Technical product information

Topic	Fuel tank internal fuel pump replacement - W12 TSI
Market area	Australia E04 Bentley rest Asia and Australia (6E04),China 796 VW Import Comp. Ltd (Vico), Beijing (6796),Germany E02 Bentley rest Europe (6E02),Japan E03 Bentley Japan (6E03),Korea, (South) E08 Bentley South Korea (6E08),United Arab Emirates E06 Bentley Middle East and Africa (6E06),United Kingdom E01 Bentley UK (6E01),United States E05 Bentley USA and rest America (6E05)
Brand	Bentley
Transaction No.	2055235/4
Level	EH
Status	Approval
Release date

This TPI is applicable for W12 Bentayga TSI engine variants only

Figure 1

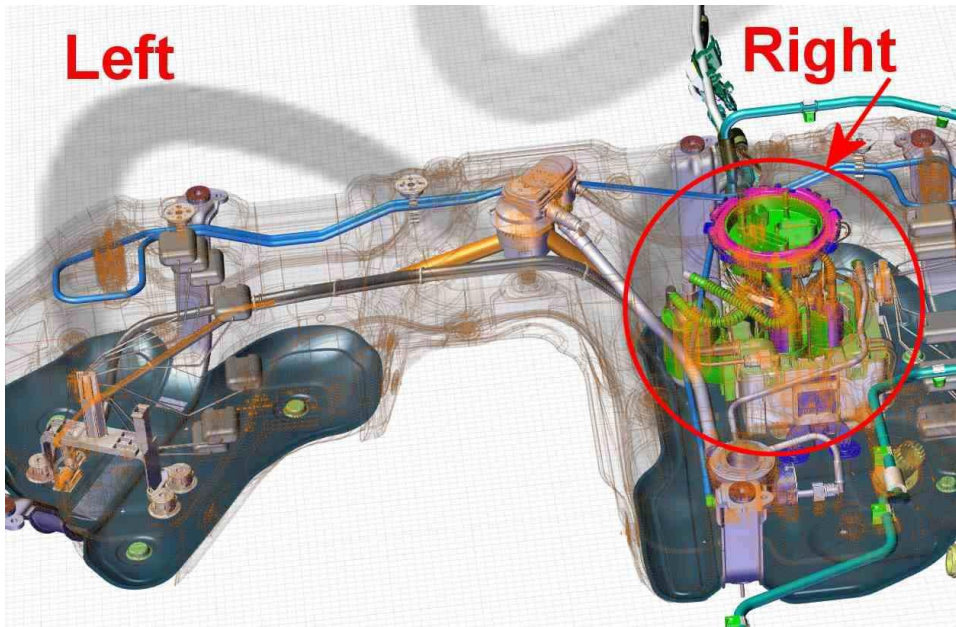
The twin fuel pumps which are part of the fuel delivery module (located on the right hand side of the fuel tank as Figure 1) have changed to an improved Diamond Like Coated (DLC) fuel pump

In the event the incorrect configuration of the fuel delivery module and control units are fitted the retailer/customer can experience a low fuel pressure too low DTC

OR

low fuel pressure too high DTC depending on the incorrect configuration.

All W12 VIN's from SJA AF1ZV9KC027000 have DLC pumps fitted with the part numbers of 36A 919 087H or 36A 919 087J (depending on auxiliary heater specification) in conjunction with fuel pump control units 4M0 906 093K

The DLC pumps are compatible and can be fitted to vehicles up to VIN SJA AF1ZV9KC027000 HOWEVER you must ensure the correct specification fuel pump control units are fitted in conjunction with the DLC fuel pump assembly

Figure 2

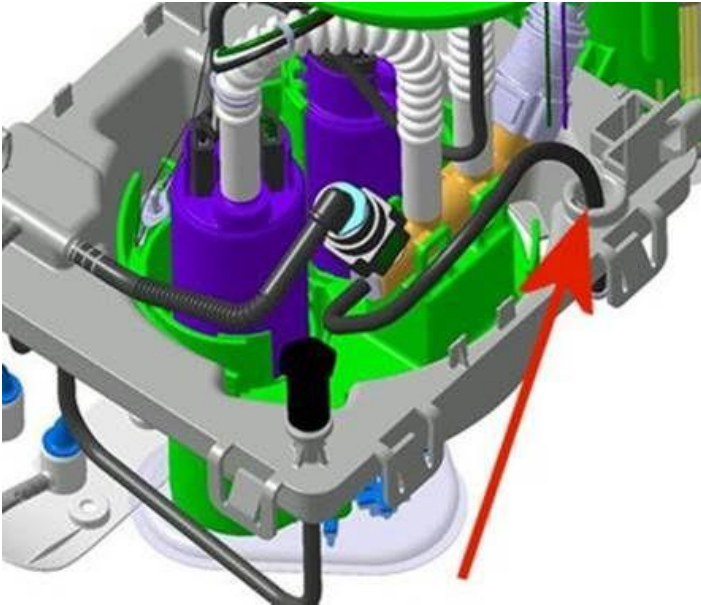
Fuel delivery module with bypass tube (Figure 2)

36A 919 087F - Fuel pump assembly without auxiliary heater

36A 919 087G – Fuel pump assembly with auxiliary heater

Fuel pump control units

36A 906 093B – Master

36A 906 093C - Slave

All vehicles - Not fitted with a bypass tube

Standard fuel pump control units with the part number - 4M0 906 093K

MUST be fitted in conjunction with

DLC fuel pumps with the part numbers of 36A 919 087H without auxiliary heater

OR

36A 919 087J with auxiliary heater

Should the vehicle require a fuel delivery module the DLC type pump assembly will be supplied 36A 919 087H or 36A 919 087J. Both fuel pump control units 4M0 906 093K should also be replaced to ensure correct configuration/compatibility

Should a fuel pump control unit require replacing the DLC fuel pump will also require replacement as control units with the part number 4M0 906 093K will only be available, In this scenario (due to potential mismatch) both control units should be replaced
